Title	EVK1100	
Size	Document Number	PROCESSOR
Date:	Friday, December 07, 2007	Sheet 1 of 13

ERRATA

REV C/

SPI

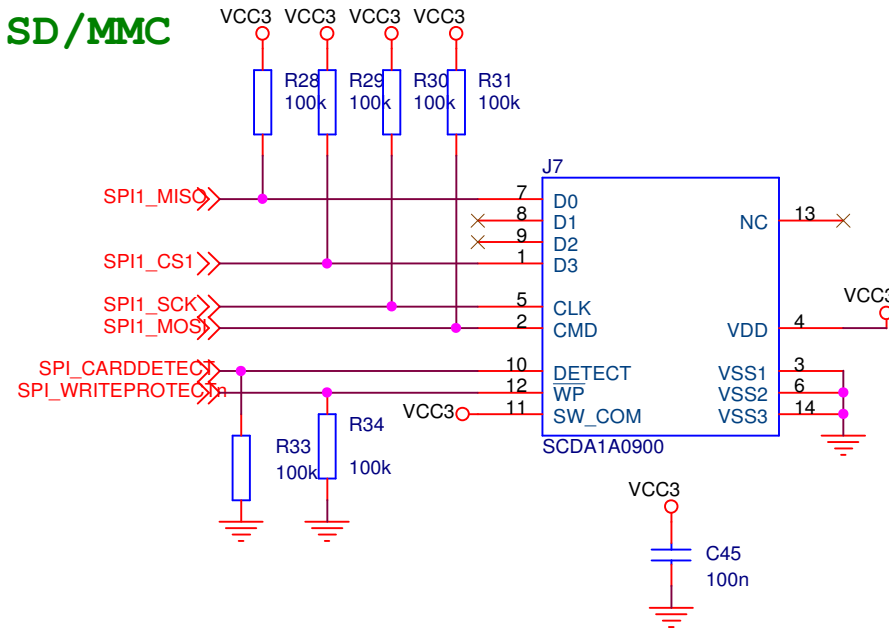
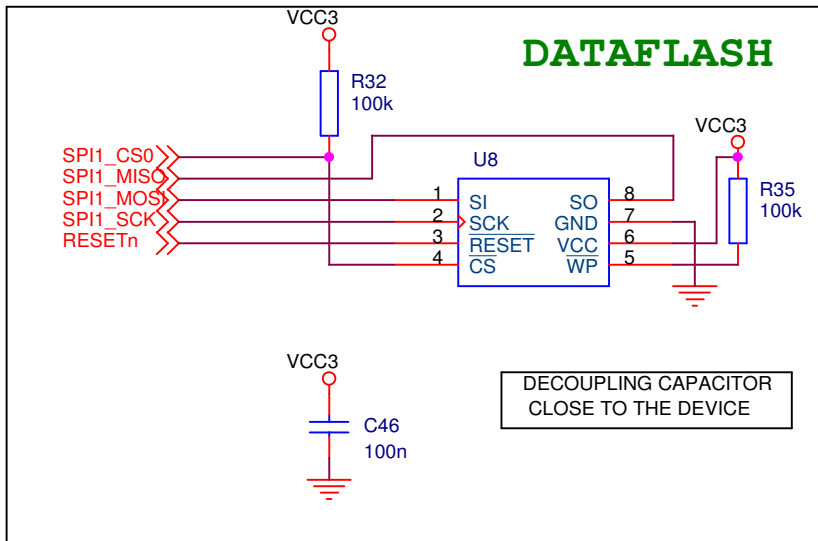
SPI

Wrong Silkscreen : MISO and SCK are swapped

USART 0

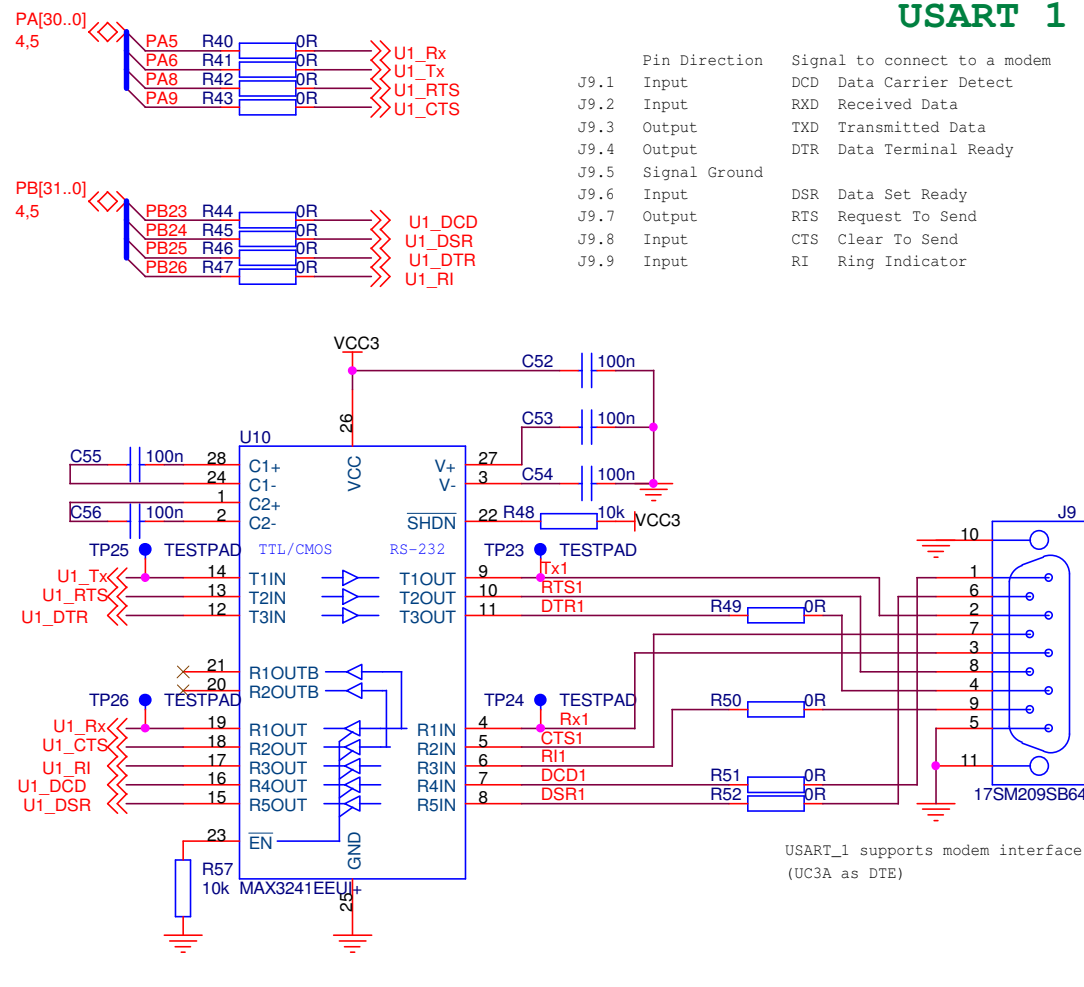
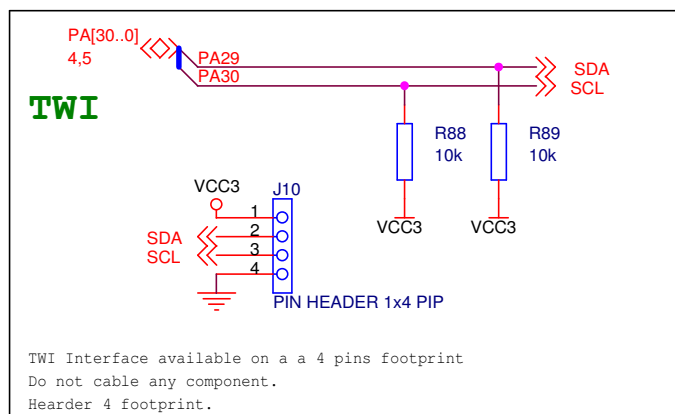
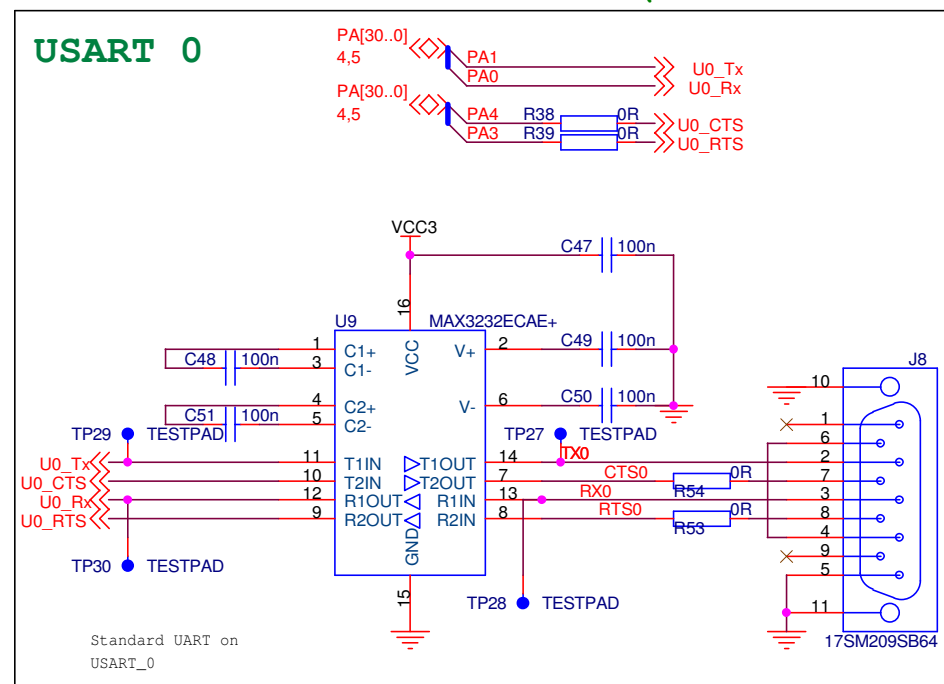
USART 0

U0_CTS (PA.4) must be connected to U9.9
U0_RTS (PA.3) must be connected to U9.10
U9.8 (R2IN) must be connected to J8.7
U9.7 (T2OUT) must be connected to J8.8

USART 1

U10.11 (DTR1) must be connected to J9.6
U10.8 (DSR1) must be connected to J9.4

LEDS

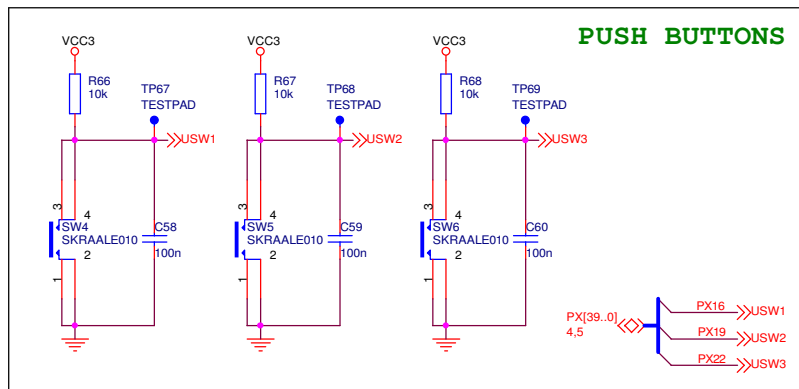
LEDS

LED 5/Green is connected to GPIO PB.19 and not to PB.20
LED 5/Red is connected to GPIO PB.20 and not to PB.19
LED 6/Green is connected to GPIO PB.21 and not to PB.22
LED 6/Red is connected to GPIO PB.22 and not to PB.21
